# SERVICE BULLETIN

SB No. 75 Issue No. 3

**TITLE**
**INSPECTION OF RUDDER PEDAL SLIDER/HEATER DISTRIBUTION BOX CLEARANCE**
**CLASSIFICATION**

**APPLICABILITY:** All T67M260 and T67M260-T3A aircraft.

FIG 1

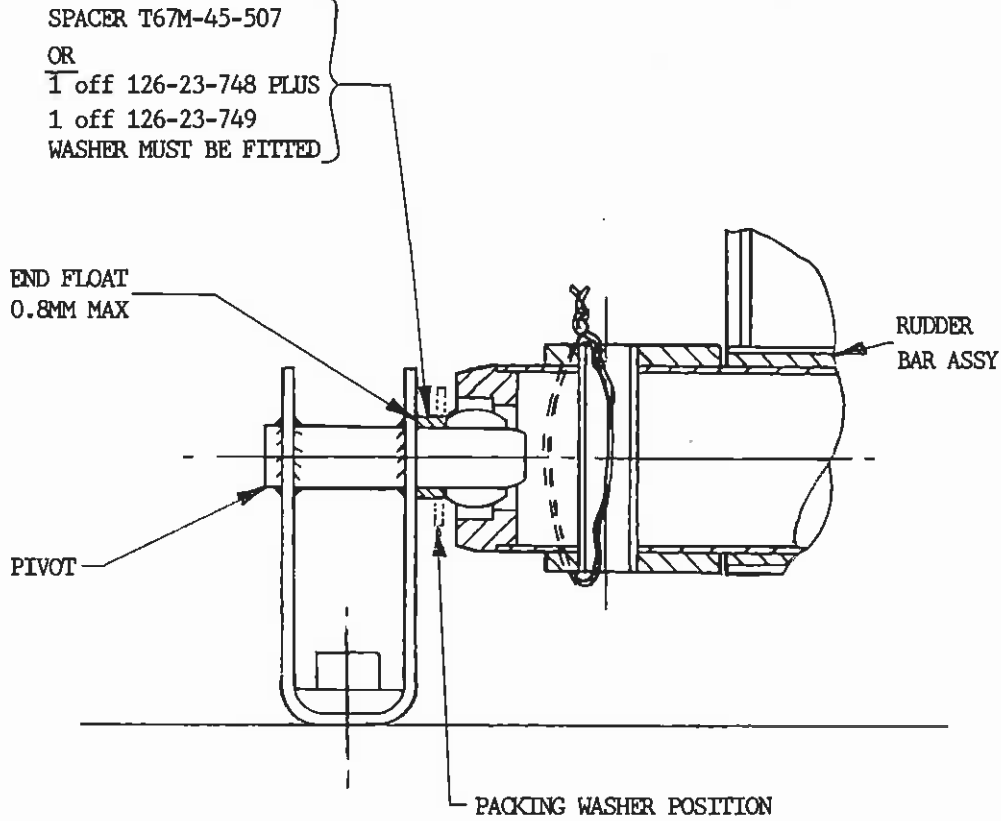
3. If clearance is found to be inadequate, proceed as follows:
  - 3.1 Check rudder bar packing is in accordance with the following, Ref. Fig. 1:

At each rudder bar pivot position (4 places) there should be one spacer T67M-45-507 OR one off each washer 126-23-748 (AN960-516) and 126-23-749 (AN 960-516L) ie 2 washers.

If end float of greater than 0.8mm is present, then 1 off only packing washer may be added at each pivot position as required, ie 126-23-105 M8 washer or 126-23-748 or 126-23-749 washers.

If packing washers are required on the right hand rudder bar (T67M-45-259) then the packing washer (or the thicker washer if a thick and thin washer are required) should be placed at the outboard pivot.

Ensure maximum end float is not greater than 0.8m and that brake cylinders are not subject to undue side load.

FIG 2

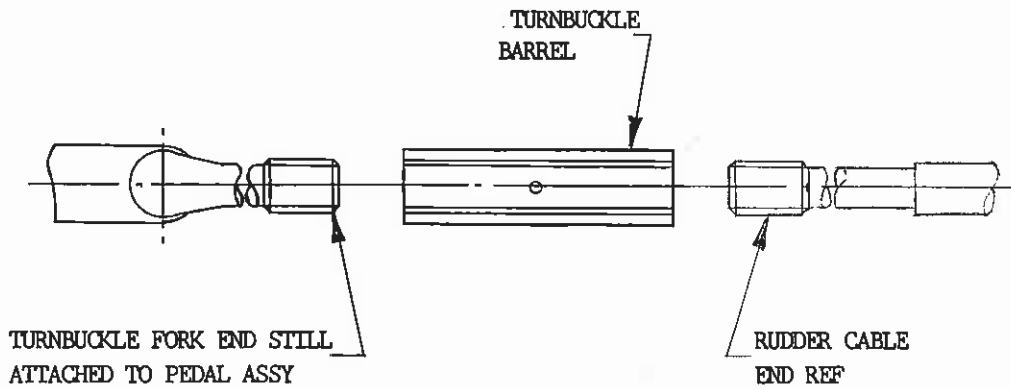
3.2.5 Disconnect turnbuckle barrel from both turnbuckle ends, see Fig. 2.

FIG 3

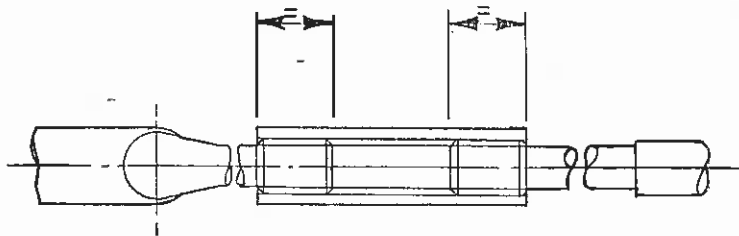
3.2.6 Re-assemble turnbuckle by simultaneously screwing onto ends ensuring equal engagement. Screw up until all of screw thread is into barrel, see Fig. 3.

FIG 4

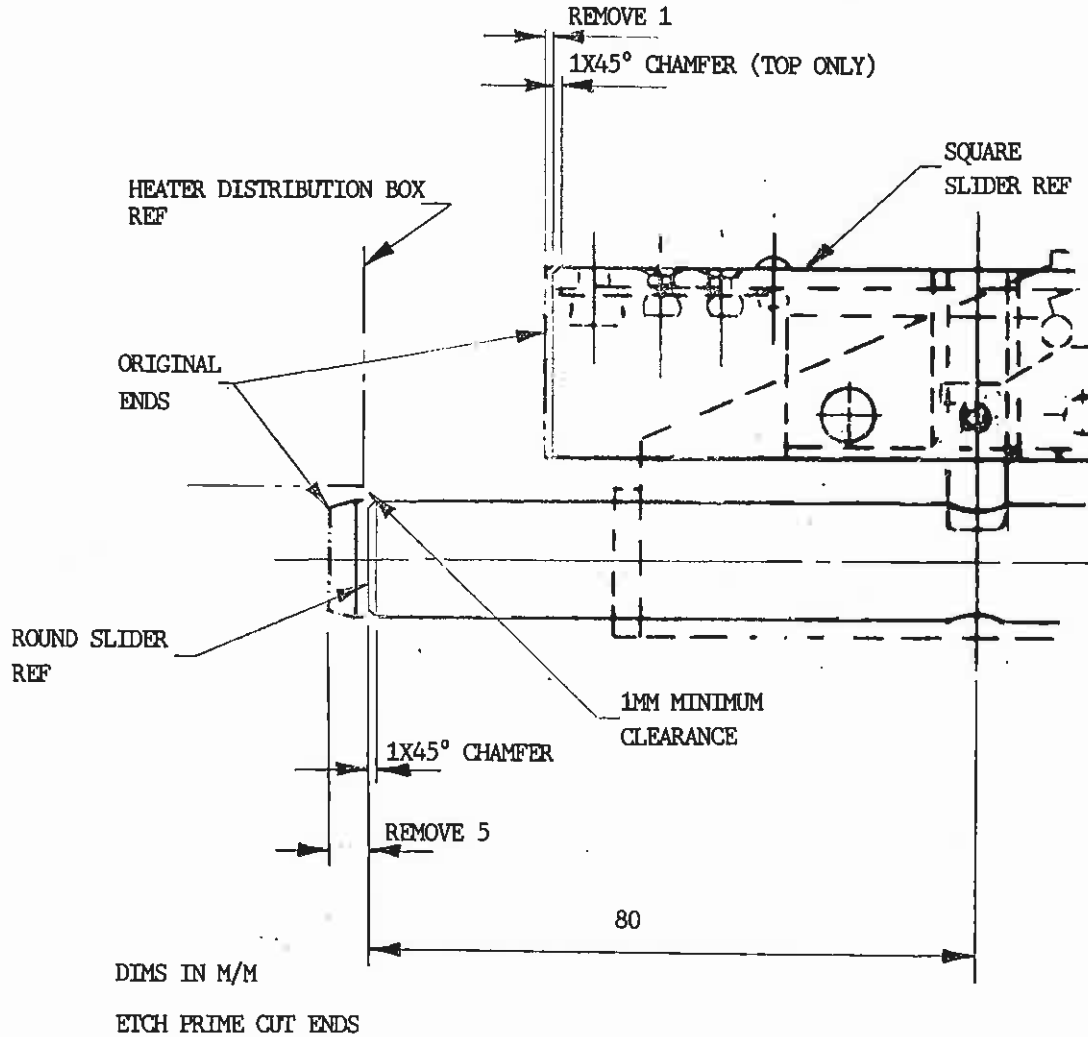
3.3 Modify pedal assy No.2 as follows:

3.3.1. Remove No.2 pedal assy and modify as per Fig. 4.

Note: Modify both square and round slider.

3.3.2 No.2 pedal assy to be re-identified as T67G-45-851 and Mod M663. Annotate Mod M663 incorporated.

FIG 5

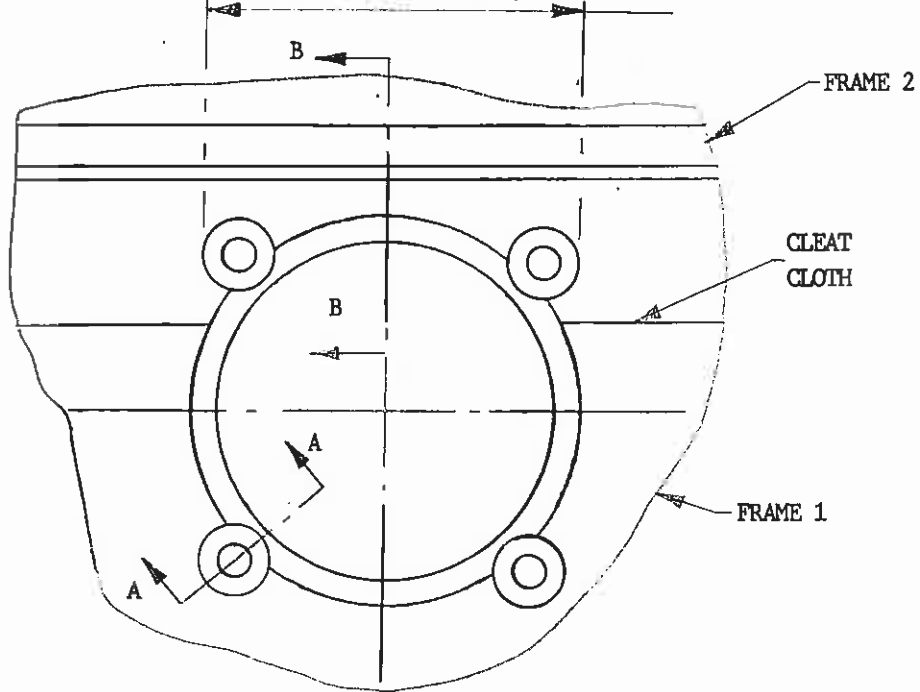
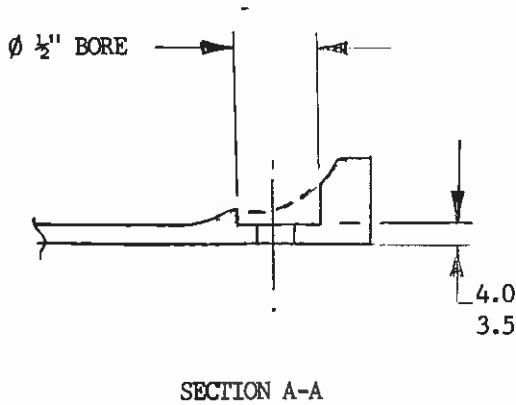
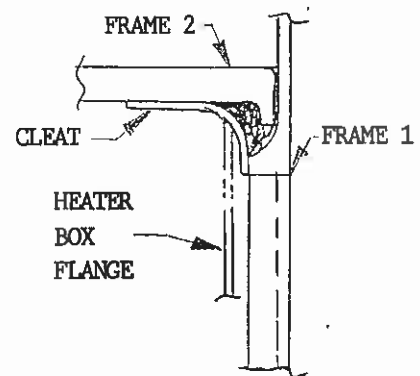
3.4 Check heater box seating as follows. Ref Fig 5.

3.4.1 Remove heater box and counter bore holes in accordance with Fig. 5 Section A-A.

3.4.2 Replace box and check seating. If box top flange fouls cleat cloth joining frame 1 to frame 2 then it is to be removed in accordance with Fig.5 Section B-B.

CLEAT REMOVE MINIMUM REQUIRE TO SEAT HOT AIR BOX
